Access Compliance Report

Public Rights-of-Way

Intersection ID: 46815	Main Street: OLDE_IVY_WY	Cross Street: ARBOR_CREST_CT	Location: S
ADA ID: BABE573DDCE3	Ramp Type: PerpDiag	Initial Pass/Fail: Fail	Overall Compliance: No
Severity Score: 60			
Codes/Mitigation Info/Possible Solution		Field Measurements/Component Compliance

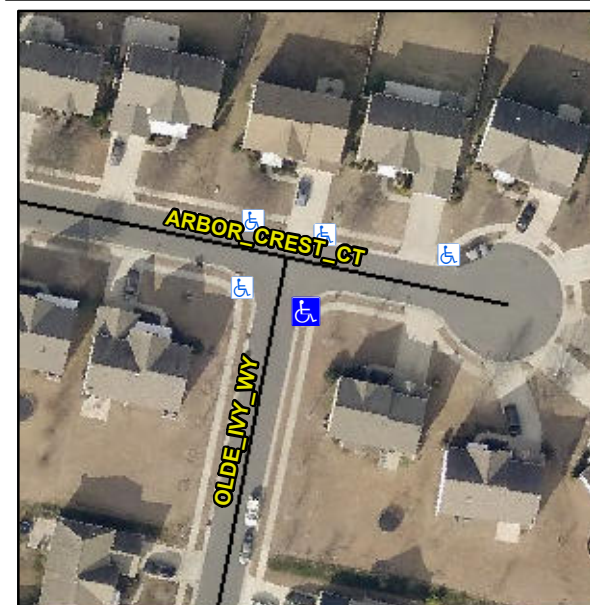
Not Found, R304.5.1, R304.2.2, R304.5.3

Compliance	Description	Data	Compliance	Description	Data
N/A	Ramp Length (in)	49.0	No	Ramp Slope (%)	10.2
No	Ramp Width (in)	29.0	No	Ramp XSlope (%)	5.9
N/A	Flare Type LT	N/A	N/A	Flare Type RT	N/A
N/A	Flare Slope LT (%)	N/A	N/A	Flare Slope RT (%)	N/A
N/A	Flare Traversable LT?	N/A	N/A	Flare Traversable RT?	N/A
N/A	Landing Length (in)	N/A	N/A	DWS Provided?	N/A
N/A	Landing Width (in)	N/A	N/A	DWS Contrast?	N/A
N/A	Landing Slope (%)	N/A	N/A	DWS Length (in)	N/A
N/A	Landing X Slope (%)	N/A	N/A	DWS Full Width?	N/A
N/A	Landing Curb? (Y/N)	N/A	N/A	DWS Offset (in)	N/A
N/A	Shared Landing?	N/A			
N/A	Gutter Ponding?	N/A	N/A	Gutter Slope (%)	N/A
N/A	Gutter Lip Ht (in)	N/A	N/A	Gutter X Slope (%)	N/A
N/A	Painted X Walk1?	No	N/A	Painted X Walk2?	No
	X Walk 1 Direction	To NE		X Walk 2 Direction	To NW
N/A	X Walk 1 Width (in)	N/A	N/A	X Walk 2 Width (in)	N/A
	X Walk 1 Slope (%)	7.0		X Walk 2 Slope (%)	2.8
	X Walk 1 X Slope (%)	2.5		X Walk 2 X Slope (%)	5.9

Remove & Replace Curb Ramp With Two New Directional Ramps or Equivalent.
